## Major Development Plan

### **Application number: MDP2016.01 Rivermist**

**Request:** The applicant requests that the City Council receive the modified plan dated November 17, 2016, and reconsider approval, with conditions, of the proposed major development plan to subdivide 44.45 acres into an 86-lot single-family residential community. The proposed community includes open space, common area, and tree preservation areas in compliance with the city land development code (LDC).

# REVISED SCHEMATIC PLAN

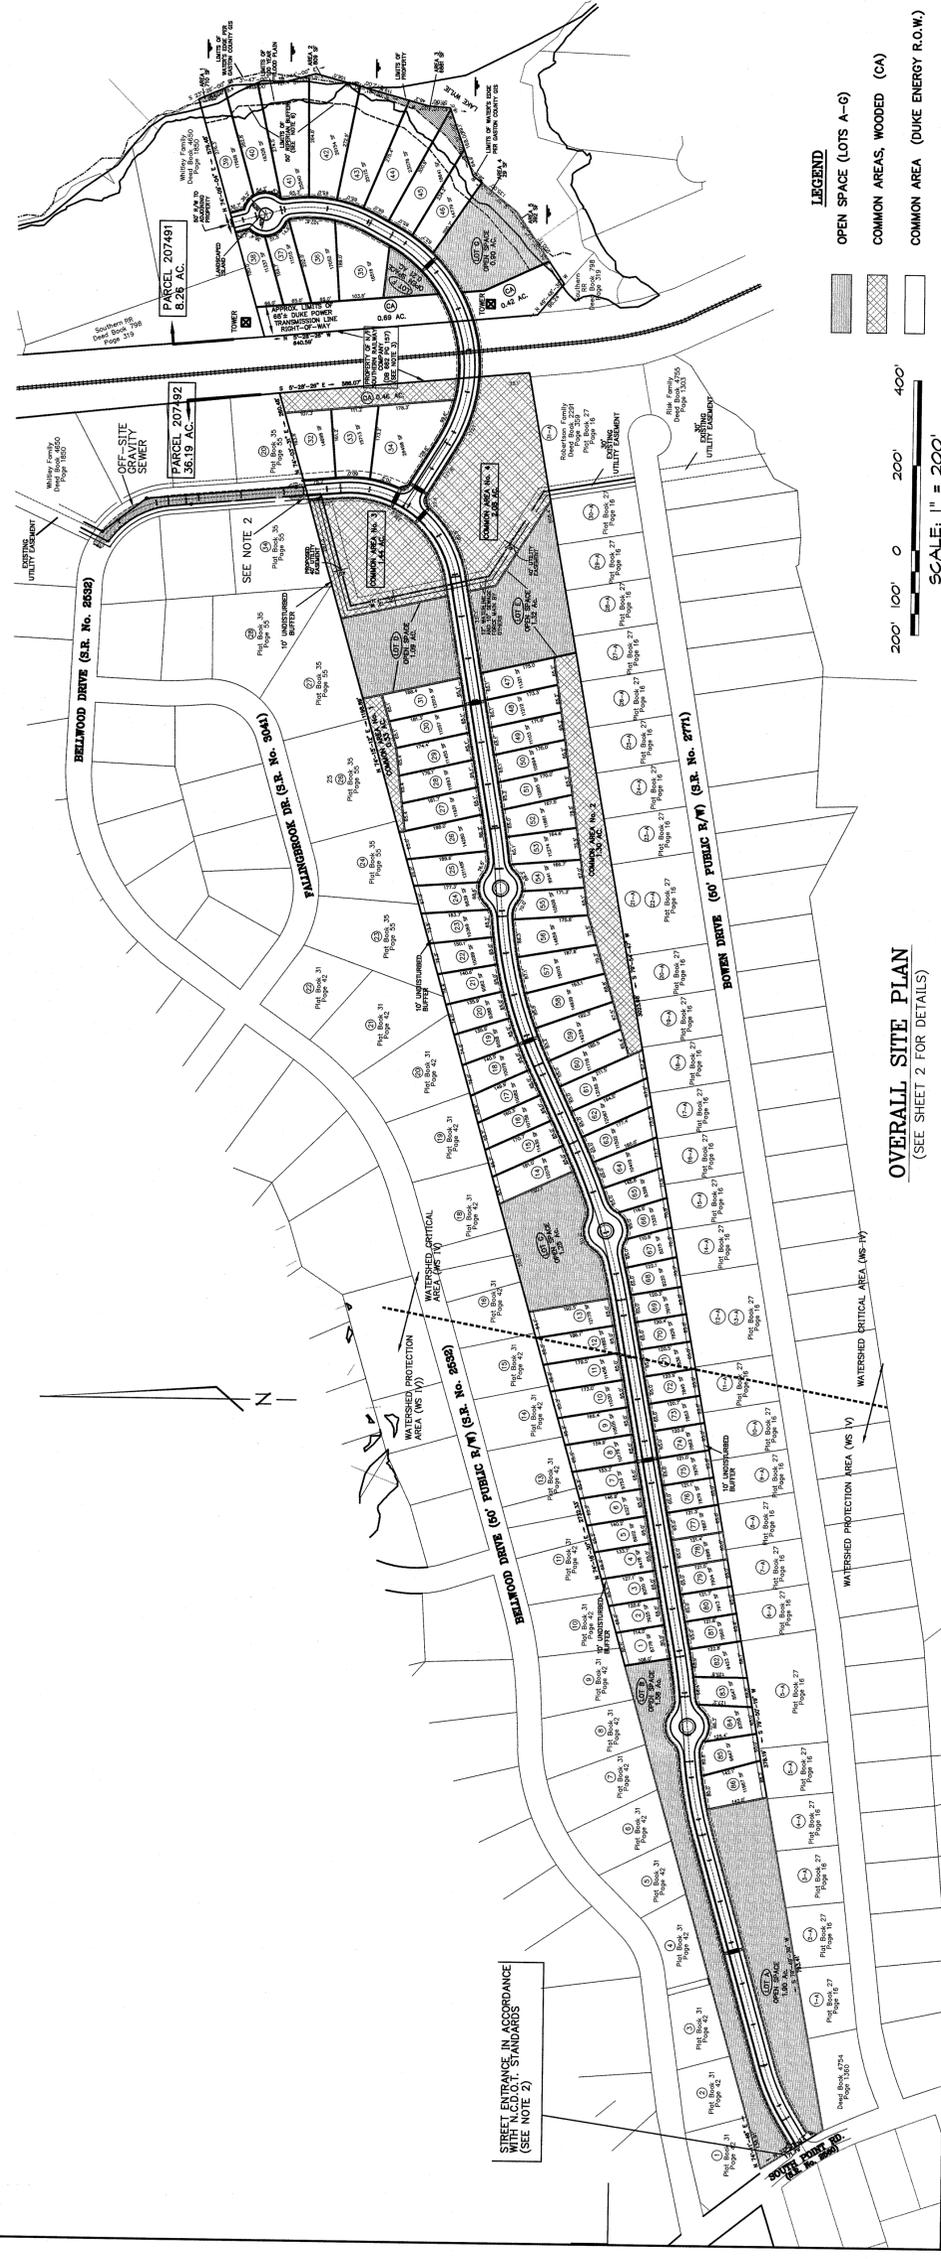
The proposed site design does not comply with this maximum block length. This was the bases for disapproval from the earlier site plan. The applicant has proposed a revised site plan reducing the lot count and adding a traffic circle for the Council's consideration. The applicant is again requesting the Council find that special circumstances exists that would permit the block length greater than 660 feet in length. The design of the development is constrained by irregular shaped lot (narrow). The proposed street design includes traffic calming features (traffic circles and pedestrian crossings) to reduce speeding within the neighborhood. Per the ordinance, the Council will need to find that special circumstances are present to approve this design (Attachment B).

It is staff's opinion that the proposed development is consistent with the LDC if the Council finds that special circumstances exist with regard to the lot configuration and/or topography to grant a block length longer than 660 feet pursuant to Section 3.4 of the LDC.

6. The utility easement proposed on the north property line of common area "3" shall be located to provide a minimum of a 10-foot wide buffer easement adjacent to lot 34 of the Belwood neighborhood. Common area #3 shall be reserved for tree preservation and/or water quality protection.
